**COMMISSION OF ARCHITECTURAL REVIEW
STAFF REPORT
December 19, 2017, Meeting**

2. COA-027102-2017 (R. Jackson)

**730 North 23rd Street
Union Hill Old and Historic District**

**Relocate a window and a door
at the rear of the structure.**

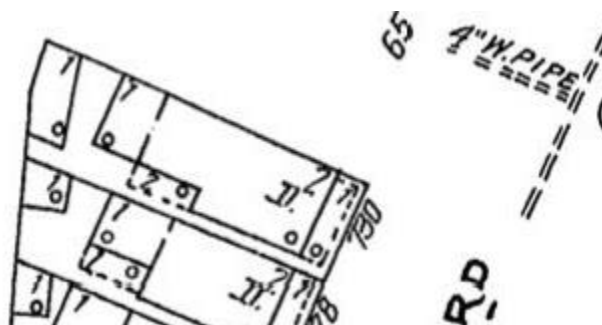
The applicant requests approval to relocate a window and a door in a frame addition at the rear of a brick single family home in the Union Hill Old and Historic District. The existing structure is a modified two-story brick Italianate dwelling with a small one-story frame addition at the rear. The applicant is proposing to replace an existing window with a door and an existing door with a window in the frame addition. The applicant is also proposing additional work to the home including replacing the existing vinyl replacement windows with aluminum clad wood windows, and repairing and repainting the brick exterior.

The *Richmond Old and Historic Districts Handbook and Design Review Guidelines* state that changes to existing windows along a secondary elevation will be considered by the Commission on a case-by-case basis (pg. 69, #8). The existing window and door opening are at the rear of the structure in a modified frame addition. A one-story addition does appear in the 1905 Sanborn map of the property, however the addition has been modified over time. The openings are visible from Jessamine Street, at the rear of the property, but visibility is minimized by a privacy fence in the rear yard. Staff recommends details of any new door or window that will be installed as a result of the modification to the openings be submitted to staff for administrative review and approval.

Staff recommends approval of the project with conditions.
